PROPOSED DRAFT GLOBAL TECHNICAL REGULATION (GTR)  
on  
PEDESTRIAN PROTECTION.

Transmitted by OICA

This document is a working document circulated for discussion and comments. It does not constitute an OICA proposal as such but is only submitted with the intention to facilitate discussion by the GRSP Informal Group.

Figure 3A. Determination of FL, RL and RWL

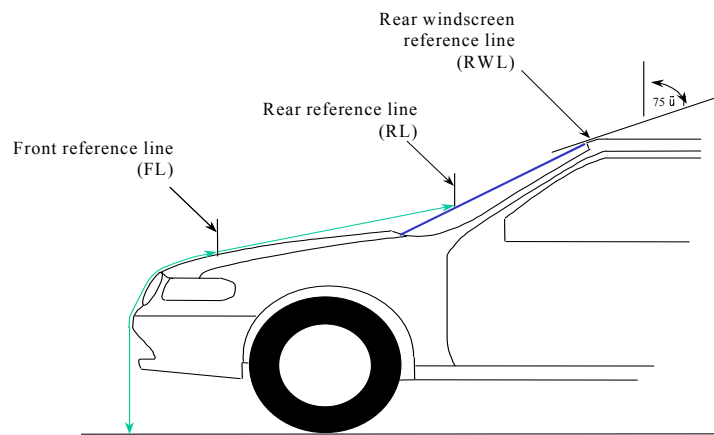
*Note: probably a sphere should be used to define RWL, as foreseen in EU*

Figure 6: Head form impactor – **to be replaced by 3.5 kg figure from EU**

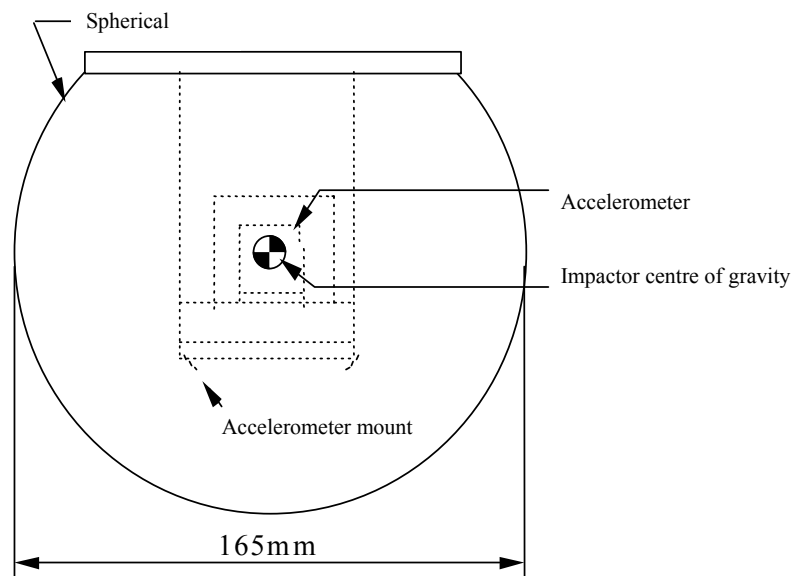
**To be corrected as per INF GR PS 74**

Figure 7: Head form impactor – **to be replaced by 4.5 kg figure from Japan**

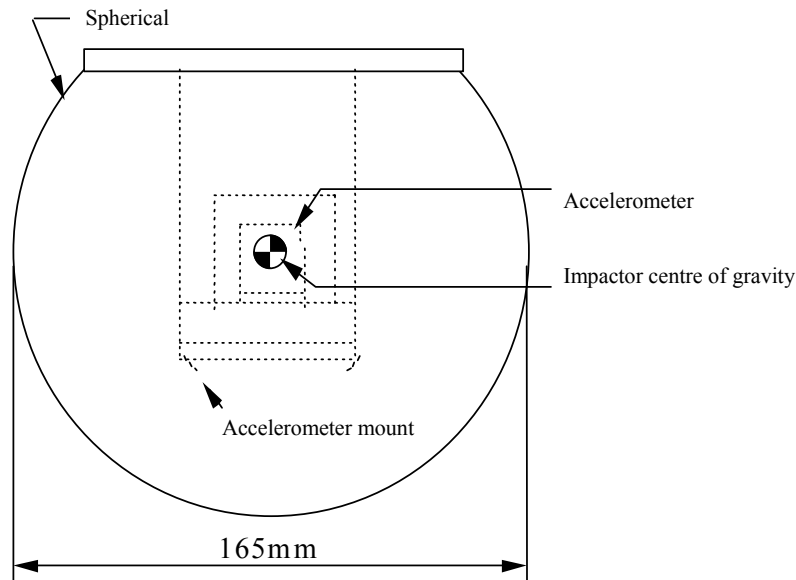
**To be corrected as per INF GR PS 74**
